REMARKS/ARGUMENTS

Claims 1-9 are pending in the application with claims 1-2 rejected.
Reexamination and reconsideration are hereby requested.

FIG. 2
(PRIOR ART)

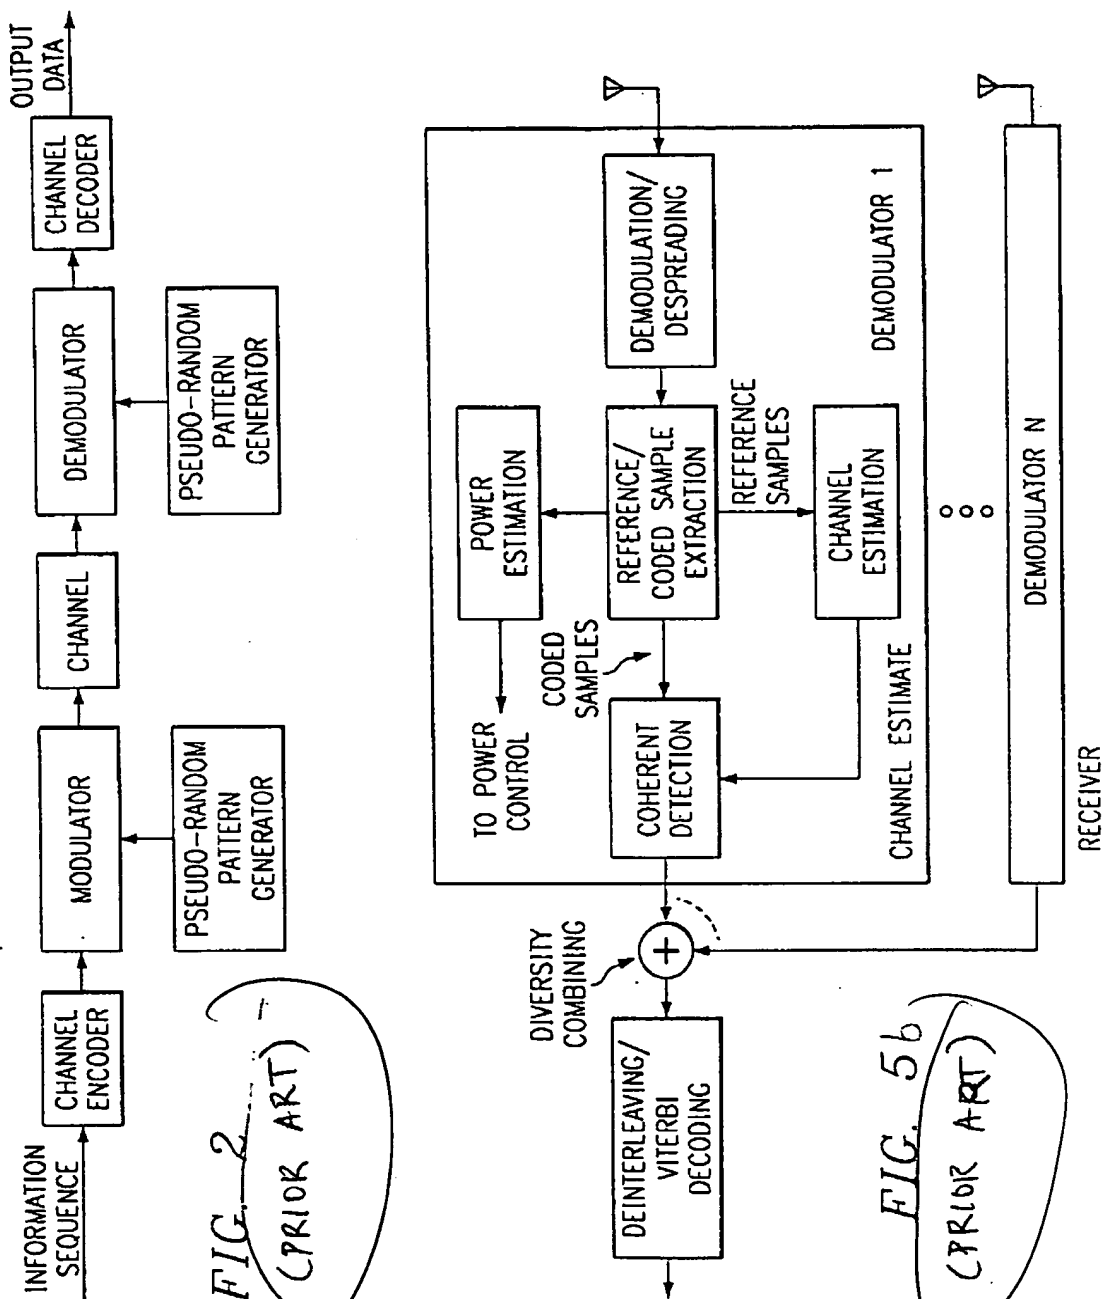
Proposed amendments to add "Prior Art" to Figs.2-5b are indicated in the Appendix in red.

approved
sc
